Service Bulletin

Bulletin No.: PI0310B

Subject: Loss of Communication with Allison Transmission Control Module (TCM), Intermittent Transmission Hesitation, Reduced Torque, Range Inhibit, Clunk, Stuck in Gear or in Neutral, Won't Shift, DTC P0880 and/or U0101 Set (Inspect for Electrostatic Discharge (ESD) From Aftermarket Serpentine Belts and/or Added Equipment, Install OEM Belt, Relocate TCM)

Models: 2007-2012 Chevrolet Silverado
2007-2012 GMC Sierra
Equipped with Allison® A1000 Automatic Transmission RPO MW7

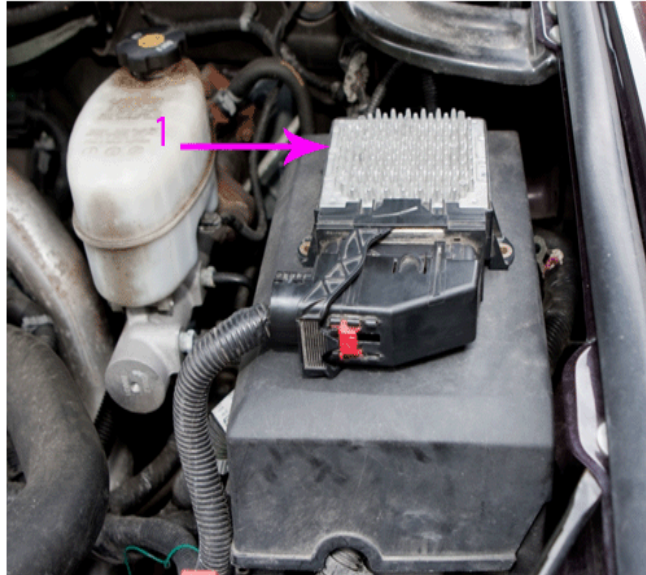
- Resistance in the G102 ground connection on the side of the engine block.
- During normal servicing, the OEM General Motors serpentine belt was replaced by an aftermarket serpentine belt.
- An aftermarket serpentine belt was intentionally installed, due to dimension changes from added aftermarket equipment such as a second alternator or clutch pump installed by an upfitter.

Certain brands of replacement aftermarket serpentine belts are made of compounds that will reduce the opportunity for audible belt noise, however these compounds can generate significant amounts of electrostatic charge on their surface. This electrostatic charge can discharge and cause DTC P0880 and/or DTC U0101 to set and be accompanied by any of the above symptoms.

3. Disconnect and inspect the G102 wire terminal and connection for looseness and corrosion. Clean any corrosion from the wire terminal and the surface of the engine block with a wire brush.
4. Apply dielectric grease to the wire terminal and engine block surface. Connect the G102 wire terminal and secure properly.
5. Inspect the engine for an aftermarket serpentine belt due to service replacement or added aftermarket equipment from an upfitter.
 - ⇒ If an aftermarket serpentine belt is installed on the original serpentine system, without added aftermarket equipment installed on the engine, replace the serpentine belt with an OEM General Motors serpentine belt. Refer to Drive Belt Replacement in SI.
 - ⇒ If an aftermarket serpentine belt is installed because of added aftermarket equipment installed on the engine, proceed to Step 6.
